AS BUILT PLANS

QUANTITY SHEET

RUTLAND STATE AIRPORT
CLARENDON, VERMONT
AIP 3-50-0015-02

NEW ACCESS ROAD AND PARKING AREA
WITH RELATED UTILITY MODIFICATIONS

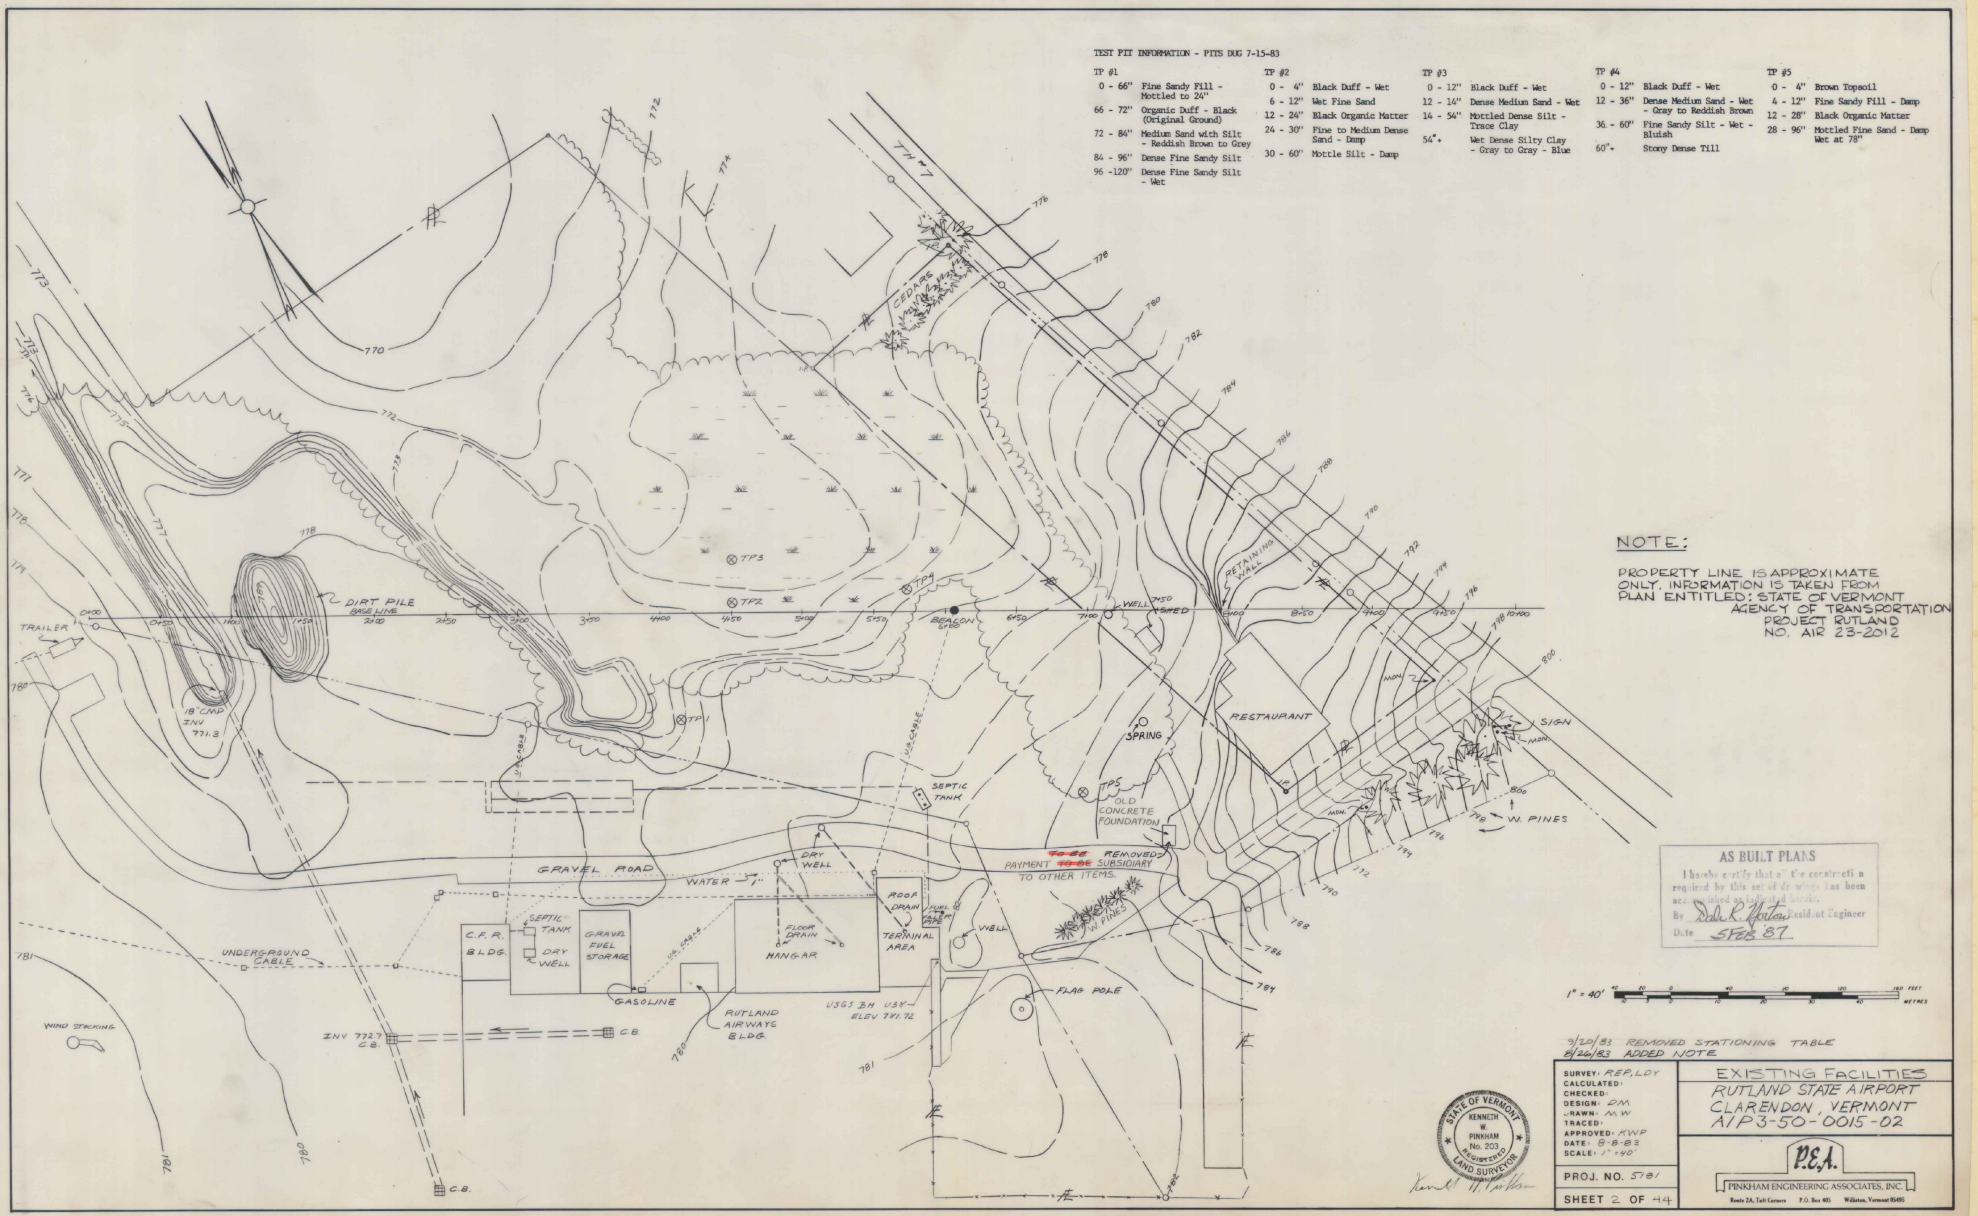
NOTE: Some of the Quantities shown above have been revised, to reflect the delation of the Northern Access rd. from this Contract. (See Sheet 3 of 44)

GORE LINE AT PARKING LOT

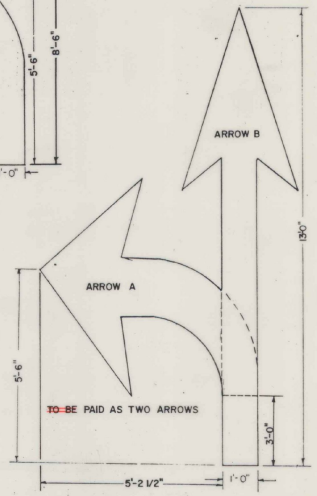
9/20/83 ADDED NOTE TO GORE LINE DETAIL
